Subject: Data Request No. 2 - San Diego Gas & Electric ("Applicant"), East County Substation Project (CPCN Application No. 09.08.003)

Suitable Burrowing Owl Habitat Overview Map

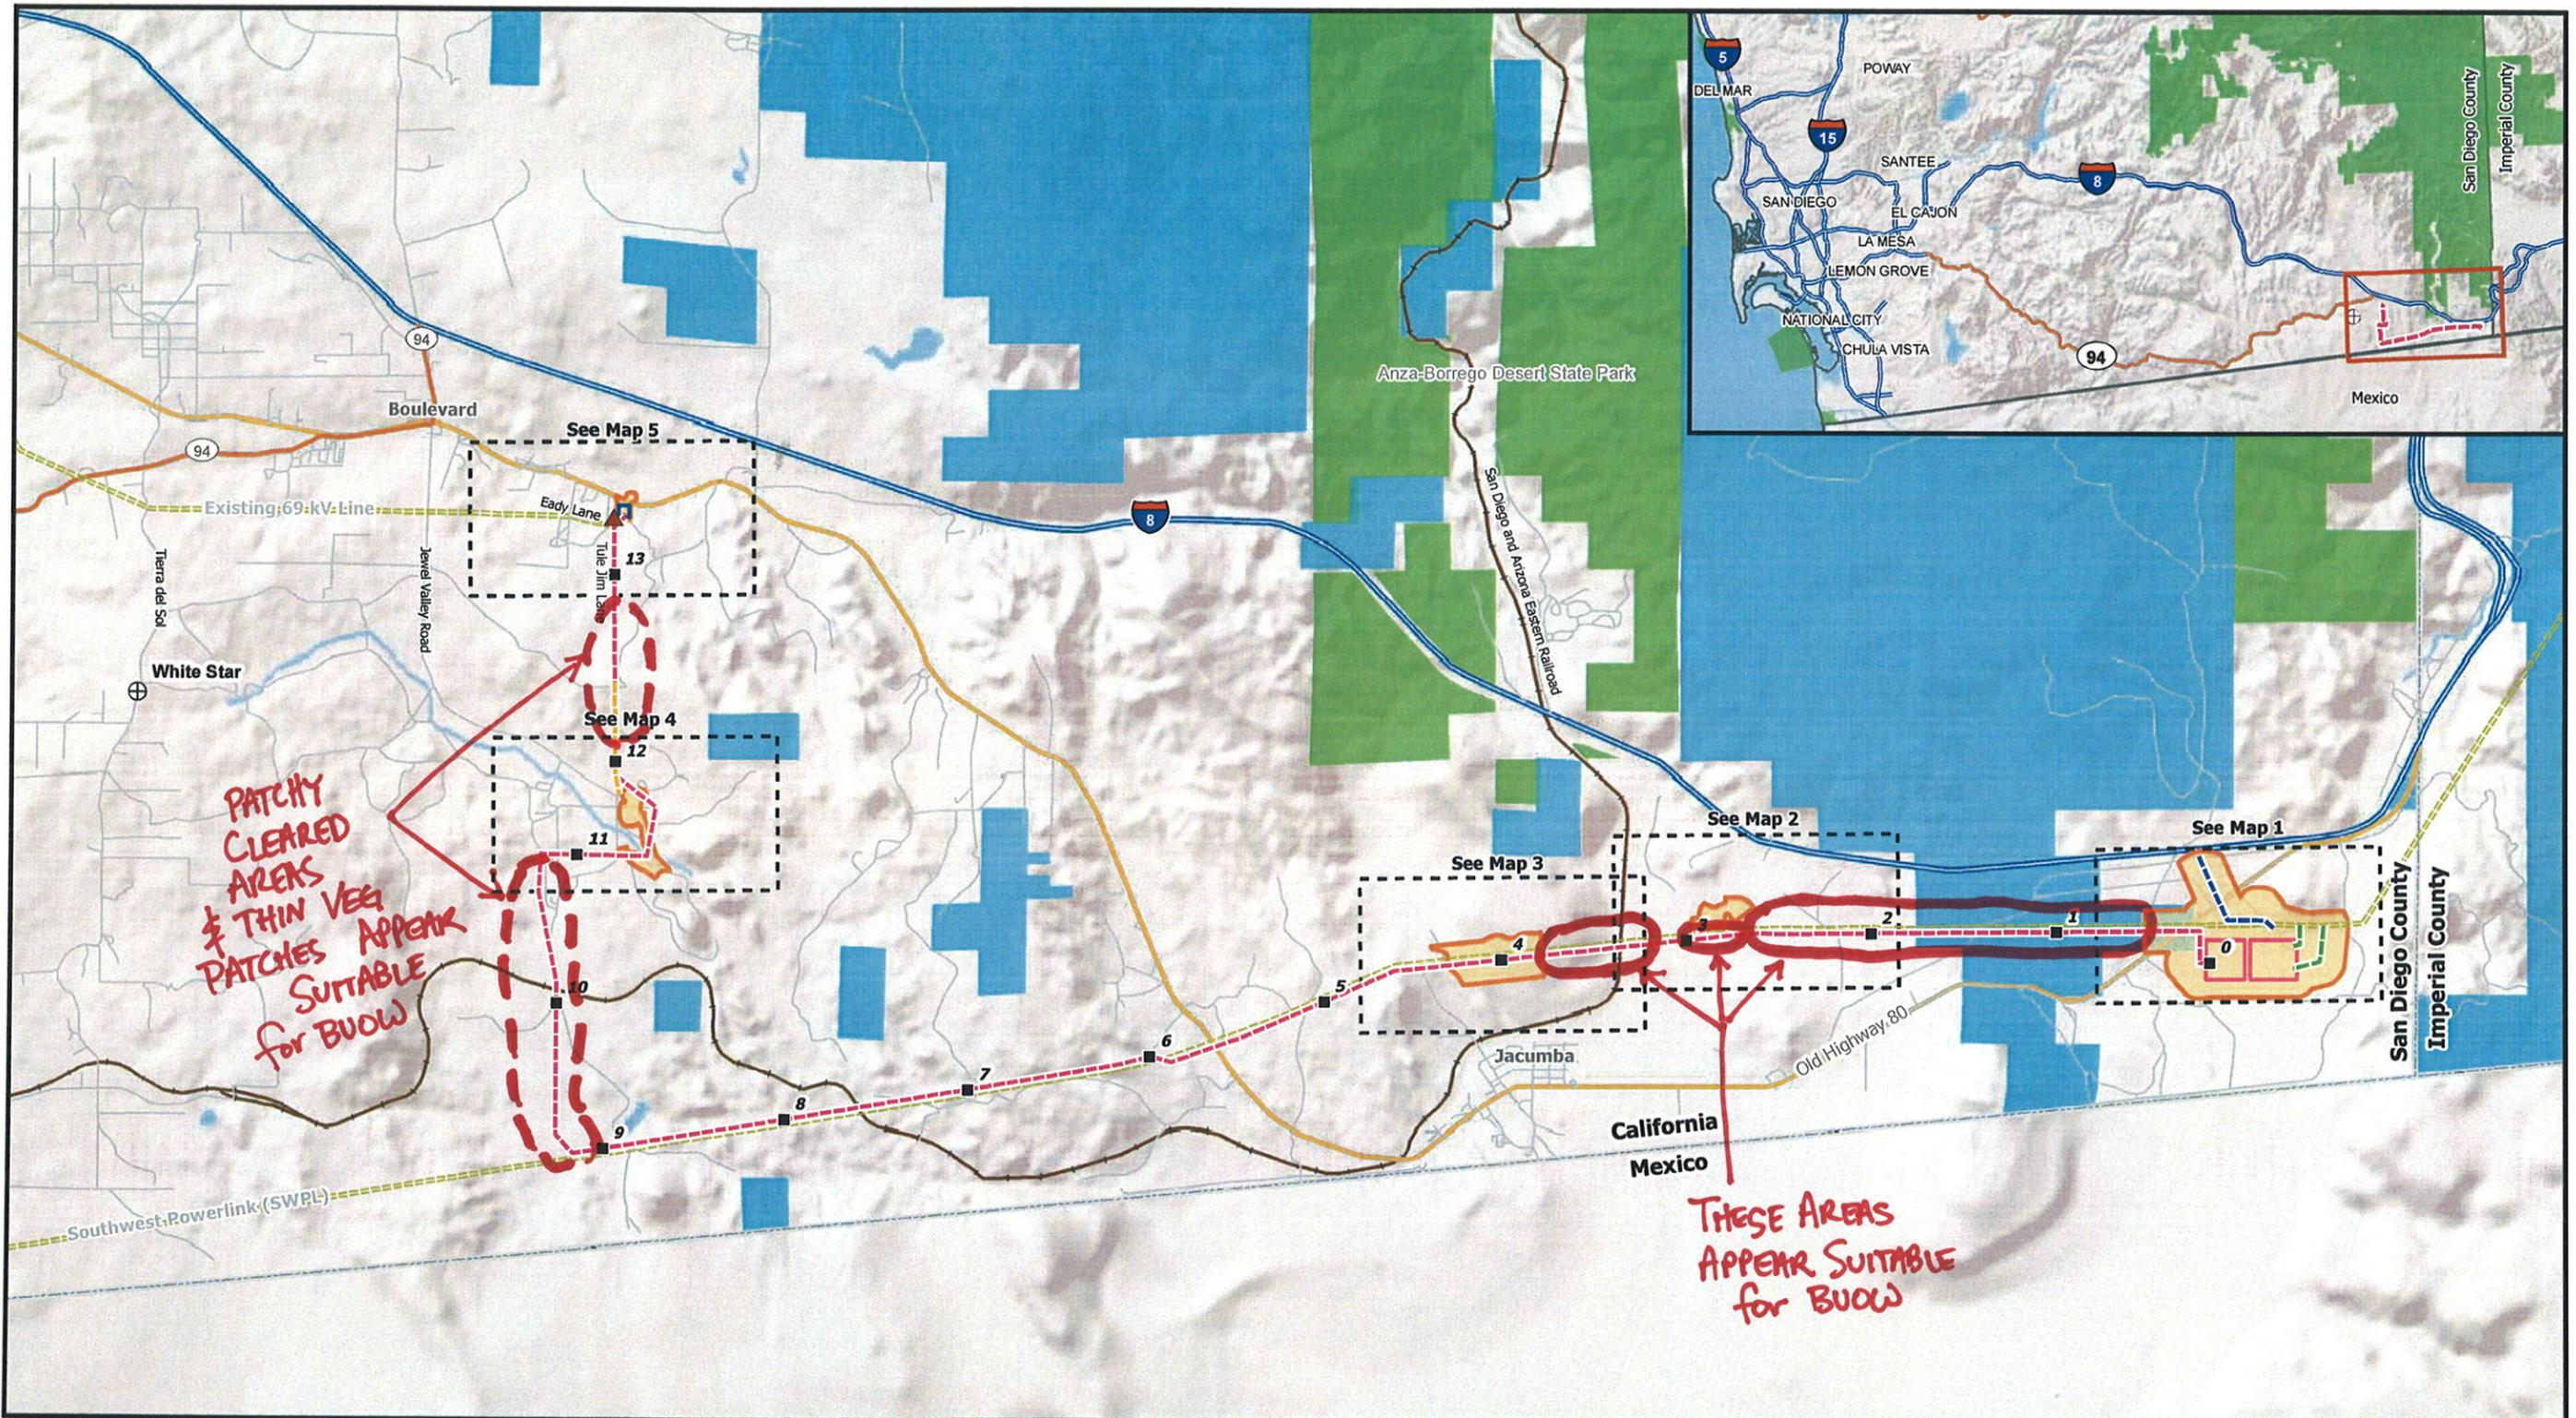
Based on our knowledge of the project area, species preferences, and a review of aerial imagery, the additional areas circled on the attached marked-up map appear to have areas suitable for burrowing owl that could also require focused surveys. We understand that the habitat assessment conducted for the entire project area may have determined these areas to lack appropriate conditions (i.e., grassland, desert, scrubland and other sparse vegetation with burrows made by other species, culverts, cement, asphalt, debris piles, or other openings). Therefore, we would request that the justification for excluding these areas be provided or expand the focused survey to include these additional areas shown on attached marked-up map.
